ALABAMA WEST SUBDIVISION ADDITIONS

APPLICATION NUMBER 15 DATE September 6, 2007

REQUEST Subdivision

DETAIL SITE PLAN

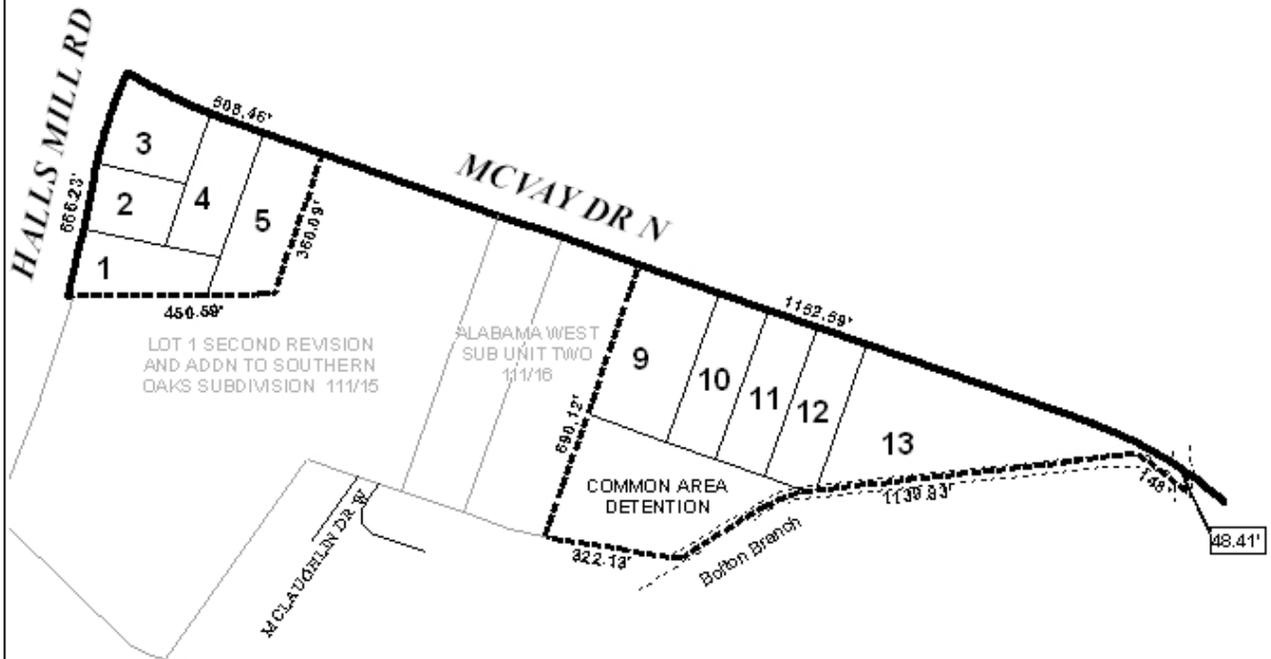
Engineering Comments: Verify that detention is not within flood plain; this is not allowed. Show all flood zones on the plat. Show minimum finished floor elevation on each lot affected by flood plain. It appears there is a drainage way on lot 13; if it conveys public water, a drainage easement is required. If there is a drainage way on-site conveying public water, any relocation of drainage way will require approval by City Engineering. It is the responsibility of the applicant to look up the site in the City of Mobile (COM) GIS system and verify if NWI wetlands are depicted on the site. If the COM GIS shows wetlands on the site, it is the responsibility of the applicant to confirm or deny the existence of wetlands on-site. If wetlands are present, they should be depicted on plans and/or plat, and no work/disturbance can be performed without a permit from the Corps of Engineers. Must comply with all storm water and flood control ordinances. Any work performed in the right of way will require a right of way permit.

The most significant difference between the previously approved plat and the plat now before the Commission is that Lot 9 has been reduced in size to accommodate a larger detention pond common area. Therefore, with the exception of the condition denying access to McLaughlin Drive North (Lot adjacent has already been recorded), all conditions of the previous approval

would still be appropriate. Unfortunately, the plat submitted does not reflect any of comments or conditions of the previous report and approval.

The site fronts Halls Mill Road, a proposed collector street, and McVay Drive, a minor street. As a proposed collector street, the two-lane Halls Mill Road should have a minimum right-of-way of 70 feet to allow for future widening, thus sufficient right-of-way should be dedicated along the Halls Mill Road frontage to provide 35 feet from the centerline of Halls Mill Road. The right-of-way for the four-lane McVay Drive meets minimum requirements. It should also be noted that the property line at the corner of Halls Mill Road and McVay Drive should reflect the minimum required curb radius detailed in Section V.D.6. of the Subdivision Regulations.

Curb cut limitations should be as follows: Lots 1-3 are limited to two shared curb-cuts onto Halls Mill Road; Lots 4-5 are limited to one shared curb-cut; Lot 6 is limited to two curbs-cuts; Lots 7-9 are limited to two shared curb-cuts; Lots 10-12 are limited to two shared curb-cuts; and Lot 13 is limited to two curb-cuts. The size, design and location of all curb-cuts to be approved by Urban Forestry and Traffic Engineering, and conform to AASHTO standards. Administrative PUD's will be required for the shared curb-cuts and internal circulation system.

The eastern portion of the site is bounded by the Bolton Branch of Dog River, and wetlands associated with the water body may occur on a portion of the site. The site, additionally, appears to be partially located in the "floodway" and "100-year" frequency flood zone as depicted on FEMA maps, and thus may be subject to flooding and hurricane-related storm surge. The presence of wetlands and floodplains indicate that the area may be environmentally sensitive; therefore, the approval of all applicable federal, state and local agencies would be required prior to the issuance of any permits.

The preliminary plat does not indicate any means of access to the proposed detention pond, a common area for the subdivision. The plat should be revised to indicate an easement or dedicated access to the detention facility. Furthermore, a portion of the detention pond appears to be located in the 100-year floodplain. A note should be placed on the Final Plat, if approved, stating that maintenance of the detention pond common areas, and any other common areas, are the responsibility of the subdivision's property owners.

The 25-foot minimum building setback line, required in Section V.D.9. of the Subdivision Regulations, is not shown for the subdivision, but would be required on the Final Plat, if approved.

1. dedication of adequate right-of-way to provide 35-feet from the centerline of Halls Mill Road;
2. revision of the plat to depict the property line radius requirements at the intersection of Halls Mill Road and McVay Drive, in compliance with Section V.D.6. of the Subdivision Regulations;

3. compliance with Engineering Comments (Verify that detention is not within flood plain; this is not allowed. Show all flood zones on the plat. Show minimum finished floor elevation on each lot affected by flood plain. It appears there is a drainage way on lot 13; if it conveys public water, a drainage easement is required. If there is a drainage way on-site conveying public water, any relocation of drainage way will require approval by City Engineering. It is the responsibility of the applicant to look up the site in the City of Mobile (COM) GIS system and verify if NWI wetlands are depicted on the site. If the COM GIS shows wetlands on the site, it is the responsibility of the applicant to confirm or deny the existence of wetlands on-site. If wetlands are present, they should be depicted on plans and/or plat, and no work/disturbance can be performed without a permit from the Corps of Engineers. Must comply with all storm water and flood control ordinances. Any work performed in the right of way will require a right of way permit.);

4. provision of 25-foot minimum building setback lines (reflecting any dedication along Halls Mill Road);
5. placement of a note on the final plat stating that Lots 1-3 are limited to two shared curb-cuts onto Halls Mill Road; Lots 4-5 are limited to one shared curb-cut; Lot 6 is limited to two curbs-cuts; Lots 7-9 are limited to two shared curb-cuts; Lots 10-12 are limited to two shared curb-cuts; and Lot 13 is limited to two curb-cuts. The size, design and location of all curb-cuts to be approved by Urban Forestry and Traffic Engineering, and conform to AASHTO standards;

6. depiction of an access easement or dedicated access to the detention pond;
7. placement of a note on the final plat stating that maintenance of the detention pond common areas, and any other common areas, are the responsibility of the subdivision's property owners; and

8. approval of all applicable federal, state and local agencies regarding the wetlands and floodplain issues prior to the issuance of any permits.
